# Framing Stage Inspection

Inspection Date: 1 Jan 2024

Property Address: 1 John St, Sydney 2000

**DIAGRAM 4.08** BOTTOM PLATES THAT OVERHANG CONCRETE SLABS

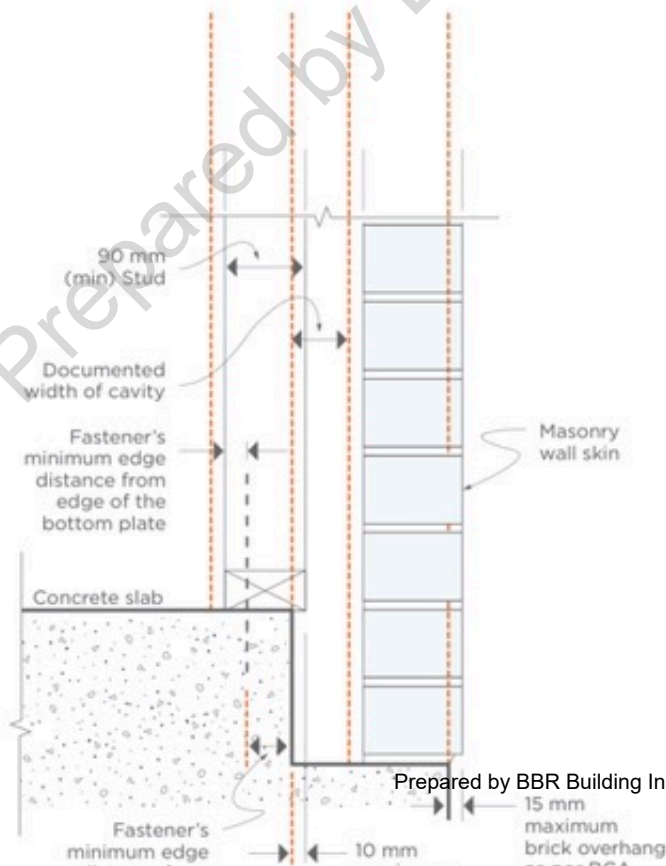
Finding: Bottom plate overhang

The floor slab in Garage area has been poured short across (front right hand side), which has left the bottom of the wall studs overhanging the edge of the slab by up to 28mm.  
New South Wales GUIDE TO STANDARDS AND TOLERANCES 2017 - 4.8 Bottom plates that overhang concrete slabs states:

Bottom plates that are less than 90 mm wide and overhang concrete slabs are defective.  
Bottom plates that are 90 mm wide or greater and overhang concrete slabs by more than 10 mm are defective.

Minimum cavity widths as required by the Building Code of Australia shall be maintained.

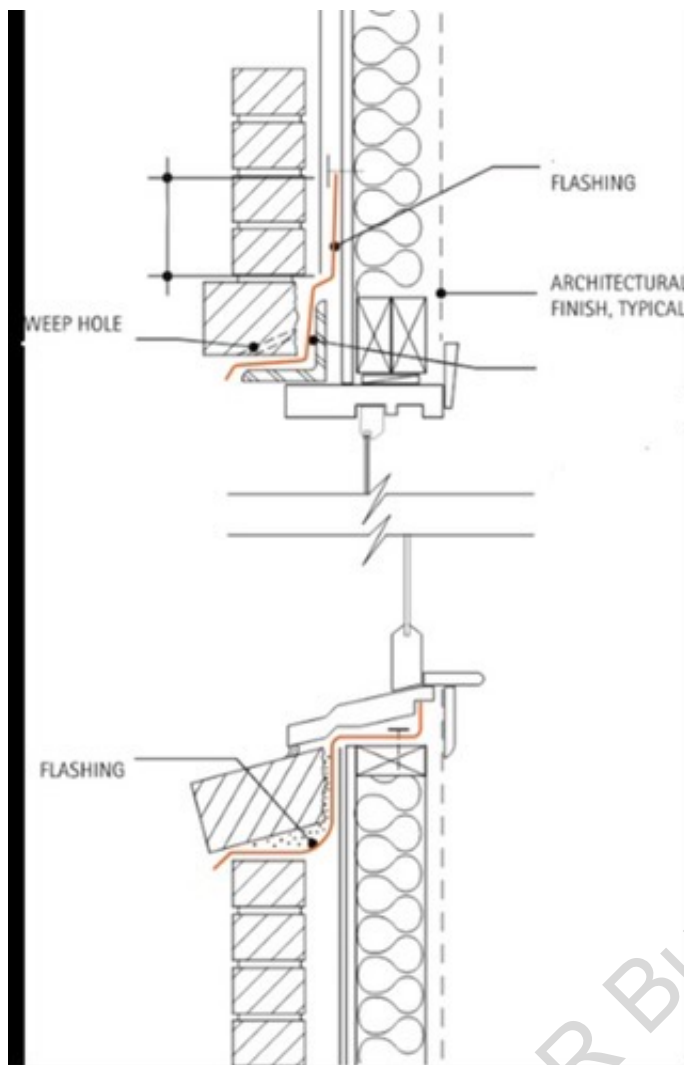
Missing windows sill, and headflashings

Sill and head flashings were missing at the time of inspection.

3.3.5.8 Damp-proof courses and flashings — installation

C) Sill and head flashings serving openings must be—

(i) installed so that the flashing extends not less than 150 mm beyond the reveals on each side of the opening;

(ii) located not more than—

A) one course below the sill brick course; and

B) 300 mm above the opening; and

turned up in the cavity not less than 150 mm above the opening; and embedded not less than 30 mm into the masonry veneer; and attached to the window or wall framing.

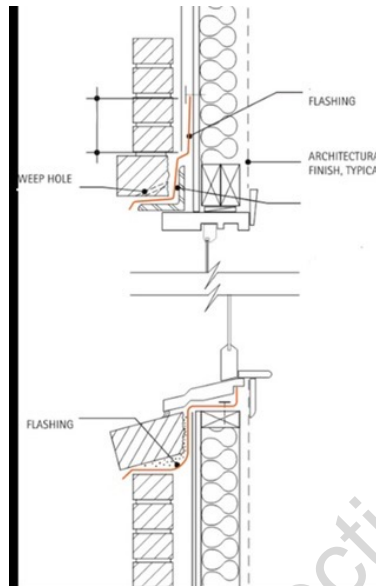
Finding: Sarking and windows head flashings not installed

Head flashings to all windows and sarking were not installed at the time of inspection.

3.3.5.8 Damp-proof courses and flashings — installation

C) Sill and head flashings serving openings must be —

(i) installed so that the flashing extends not less than 150 mm beyond the reveals on each side of the opening;

(ii) located not more than —

A) one course below the sill brick course; and

B) 300 mm above the opening; and

turned up in the cavity not less than 150 mm above the opening; and embedded not less than 30 mm into the masonry veneer; and attached to the window or wall framing.

Figure 3.5.4.5 Weather protection of openings

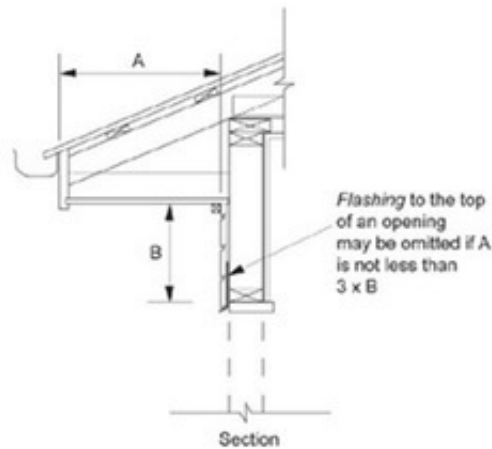
Finding: Missing windows sides and head flashings

Sides and head flashings were missing at the time of inspection however sill flashings were witnessed (except window in bedroom 3, not installed at the time of inspection). Please refer to architectural drawings for sectional claddings. Flashing required to sides of the windows where the external cladding is installed.

(a) Flashings must be provided to bottom, tops and sides of openings, except as permitted by

(d) The top of an opening need not be flashed where it is adequately protected by an eave of a width more than 3 times the height of the cladding above the opening (See Figure 3.5.4.5).

## (d) Metal straps—Tensioned—With stud straps

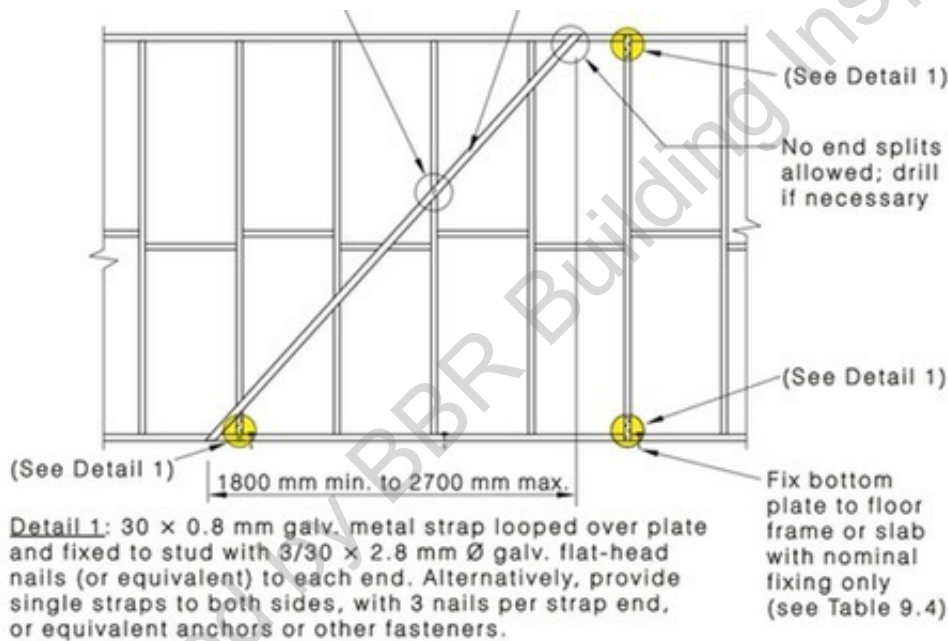
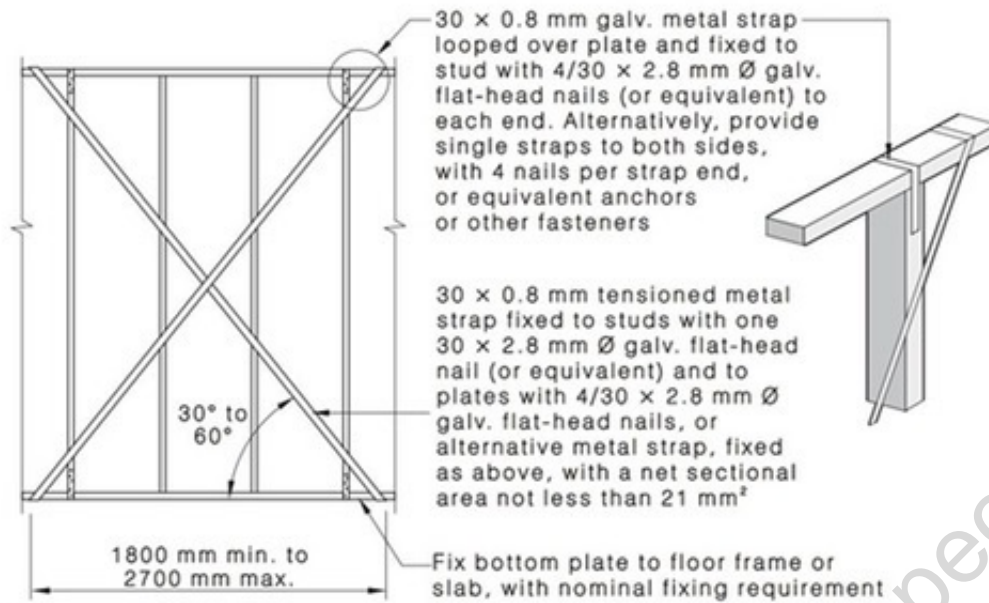
Finding: Missing metal straps to top and bottom plates

During my inspection I found no metal strap connections to the timber stud walls where the bracings installed.

It is a requirement of Australian Standard, AS 1684 Residential Timber-Framed Construction, clause 8.3.6.3 Structural wall bracing that

"30 0.8 mm galv. metal strap looped over plate and fixed to stud with 3/30 2.8 mm galv. flat-head nails (or equivalent) to each end. Alternatively, provide single straps to both sides, with 3 nails per strap end, or equivalent anchors or other fasteners. x x Ø D e t a i l : 3 0 0 . 8"

FIGURE 6.11 FIXING OF TRUSSES TO A NON-LOADBEARING INTERNAL WALL

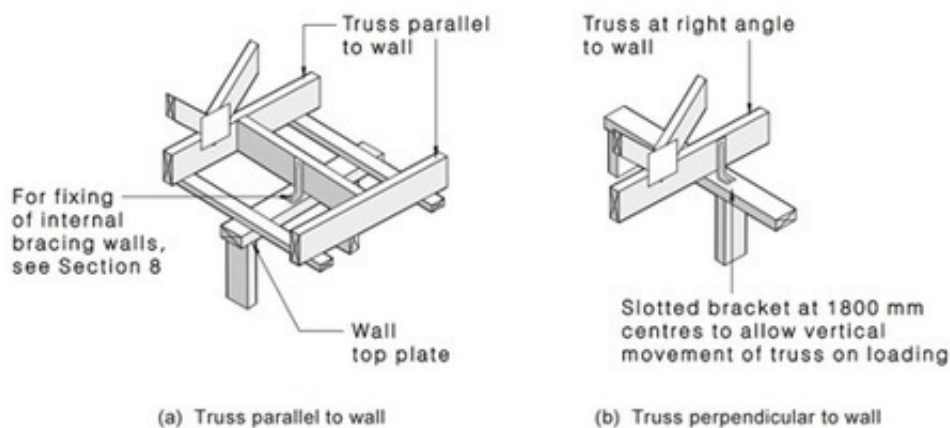
Finding: Fixing of top of bracing walls to trusses

No internal wall to truss brackets noted at the time of inspection, unless otherwise advised by the manufacturer. It is a requirement of Australian Standard, AS 1684 Residential Timber-Framed Construction, clause 6.2.5.2 Internal walls—Trussed roofs Non-loadbearing walls shall be kept a minimum of 10 mm below the underside of the bottom chord, or ceiling battens when used. Trusses shall be fixed to internal non-loadbearing walls as shown in Figure 6.11, or as required for bracing (see Clause 8.3.6.9).

Clause 8.3.6.9 Fixing of top of bracing walls;

3 For trussed roofs, where nominal fixings are permitted as above, the nominal fixings should permit vertical movement of the trusses. See Table 8.22, Items (a) and (i)

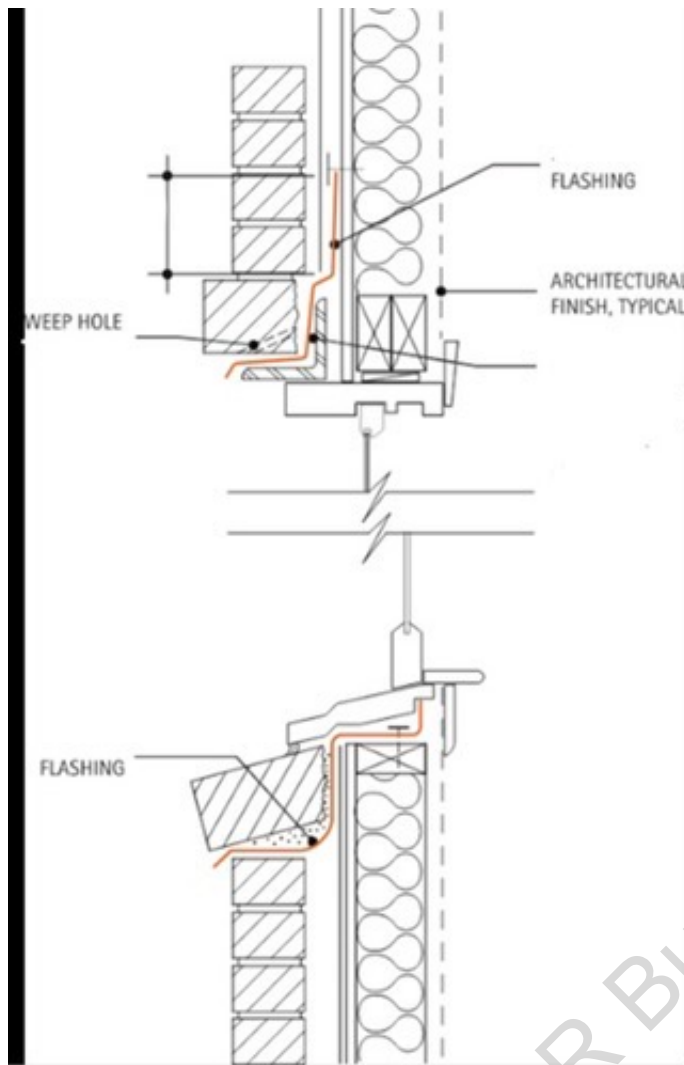
Finding: Missing windows sill and head flashings

Sill and head flashings were missing at the time of inspection.

3.3.5.8 Damp-proof courses and flashings — installation

C) Sill and head flashings serving openings must be—

(i) installed so that the flashing extends not less than 150 mm beyond the reveals on each side of the opening;

(ii) located not more than—

A) one course below the sill brick course; and

B) 300 mm above the opening; and

turned up in the cavity not less than 150 mm above the opening; and embedded not less than 30 mm into the masonry veneer; and attached to the window or wall framing.
